Final Reclamation and Stormwater Inspection

Operator: PDC ENERGY INC - 69175

Location ID: 306702

Inspection Photos
Location Name: Rothe 14-29U
Location ID: 306702

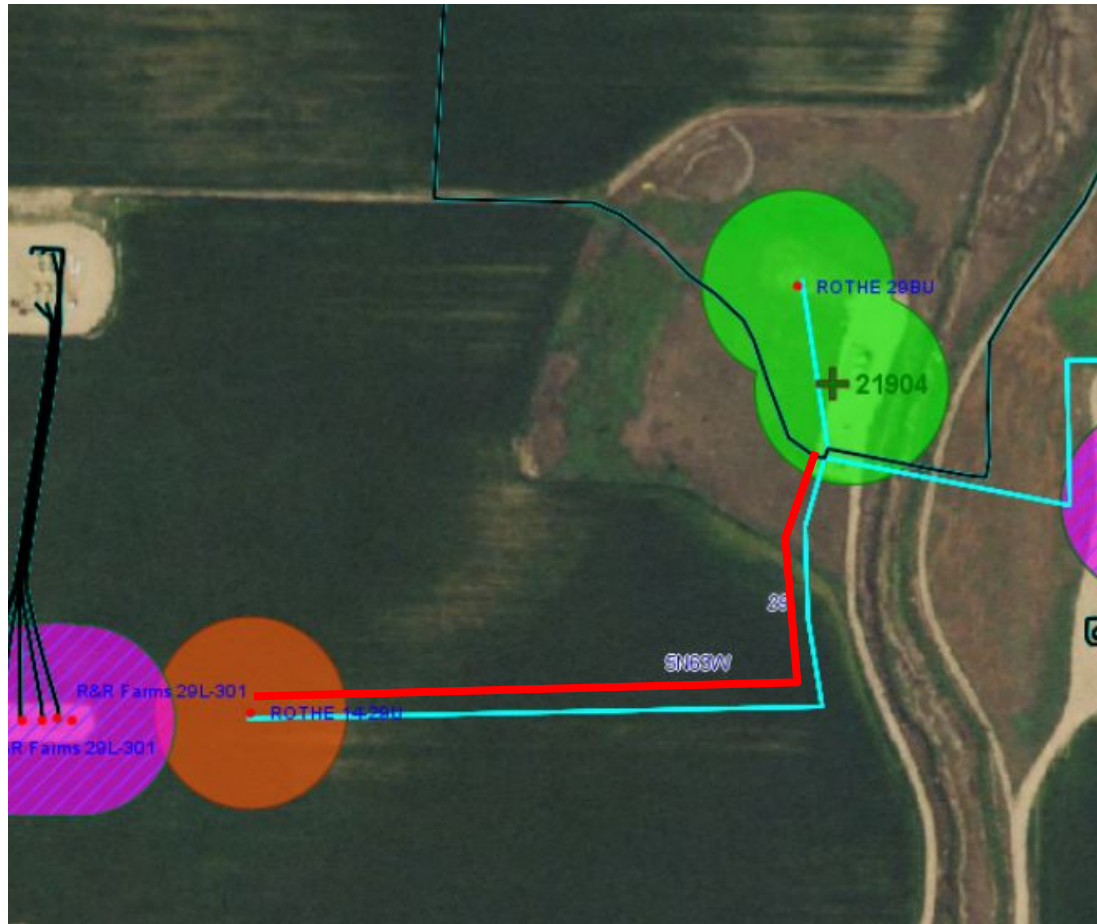
Photo 6. Red line illustrates off-location flowline from the subject well (API 123-25134) to the associated tank battery. Operator is required to submit a Form 44 Off-Location Flowline Abandonment Notice per Rule 1105.f.(2)
